***ADDENDUM No. 2 TO THE
MASTER DRAINAGE REPORT
FOR SILVERSTONE***

ADDENDUM No.2

COS #425-SA-2006, 315-ZN-2006, PC#3476-06-2

- Addendum No.2 to the Master Drainage Report Silverstone- March 2007
- City of Scottsdale, Stormwater Management Division, Approved 3/18/07 (Original) Addendum No. 1 approved 3/6/14.

EXHIBIT 3 - PRE-EXISTING
CONDITION MAP
PARCEL E

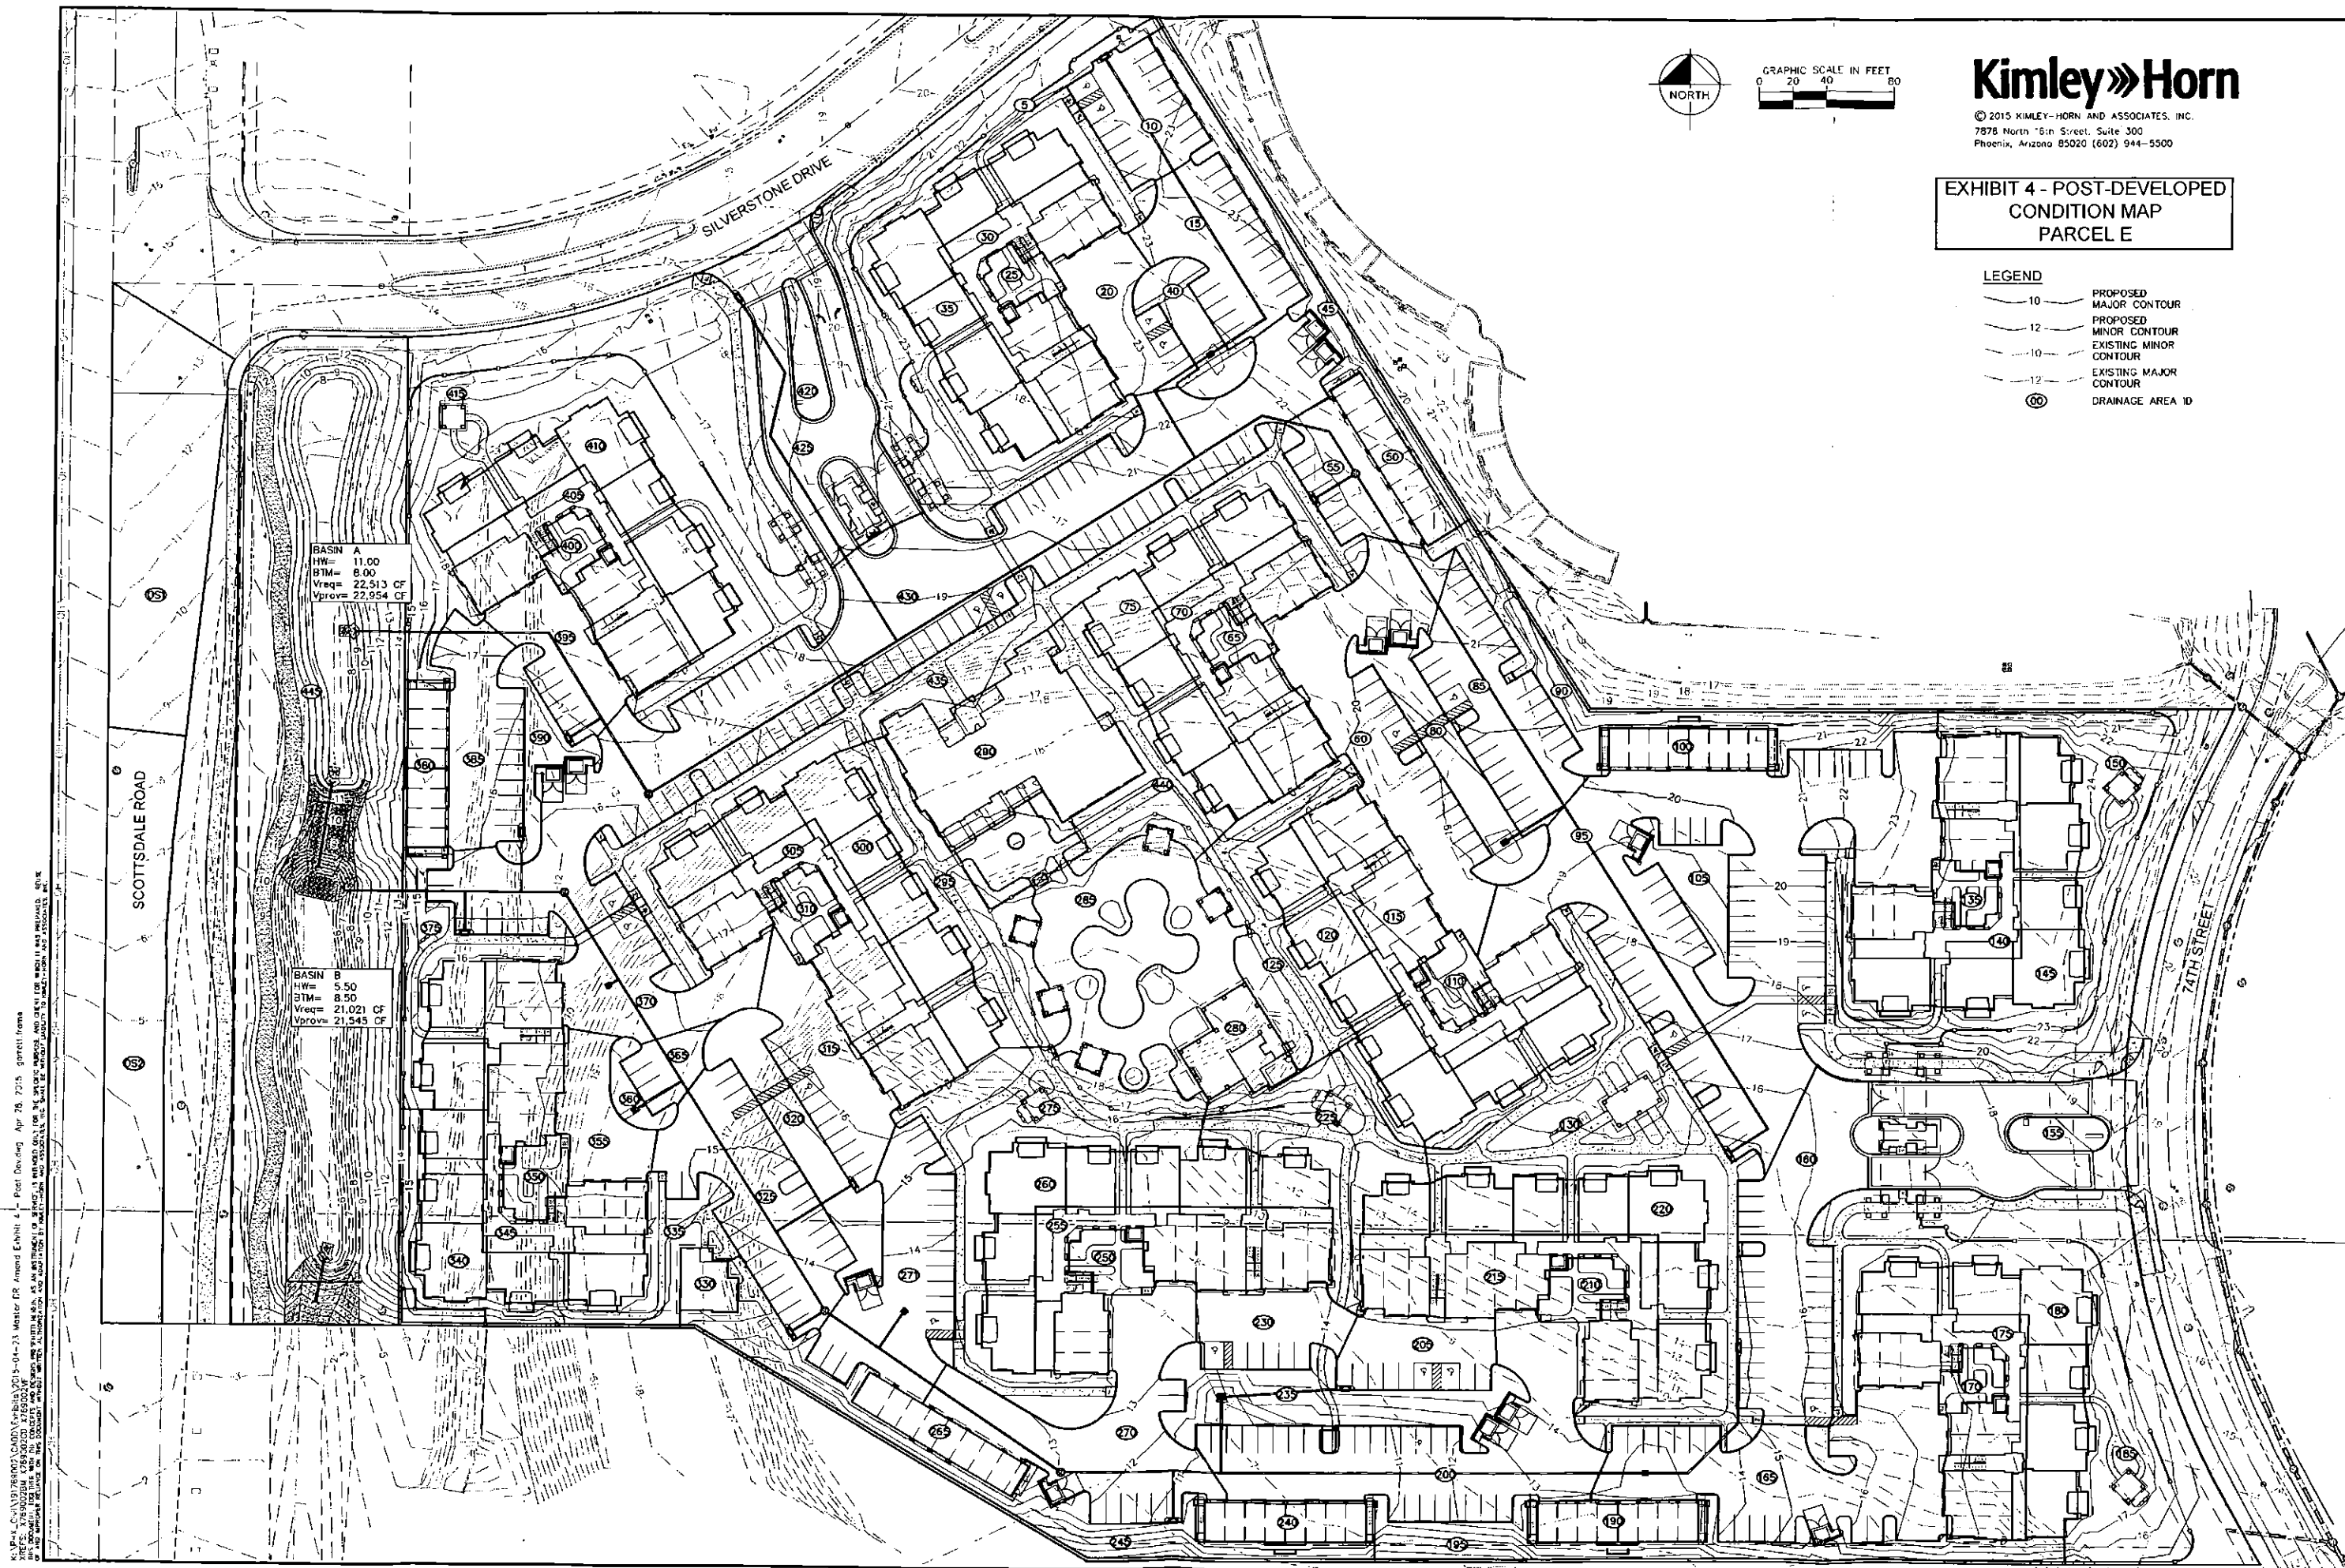
- The following are added to Appendix B.
 - Table B4- *Parcel E required Stormwater Detention Volume.*
 - Table B5- *Parcel E Pre-Existing Condition Runoff Coefficients*
 - Table B6- *Parcel E Post-Development Condition Runoff Coefficients*
 - Exhibit 3- *Pre-Existing Condition Map Parcel E*
 - Exhibit 4- *Post Developed Condition Map Parcel E*
